TO: Customers

From: USA Automatic Team

Subject: Control board changes required for UL325 7<sup>th</sup> Edition effective Aug. 1, 2018

#### Patriot Replacement Control Board – Swing and Slide

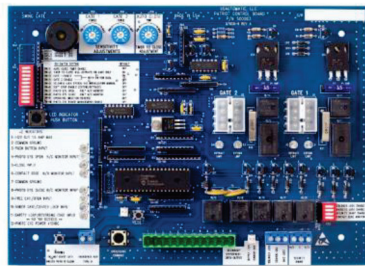
This board replaces the 500002-control board. The control board now has 2 monitored entrapment photo eye inputs one for the Open and Close direction. Still has the Pre-2016 jumper for installation into systems manufactured before January 2016.

#### Patriot Swing Gate Operator Control Board

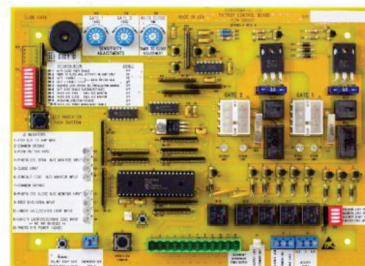
Requires a minimum of 2 entrapment devices in both directions. Exception: if no entrapment areas are identified in one direction of travel then only one device is required for that direction.
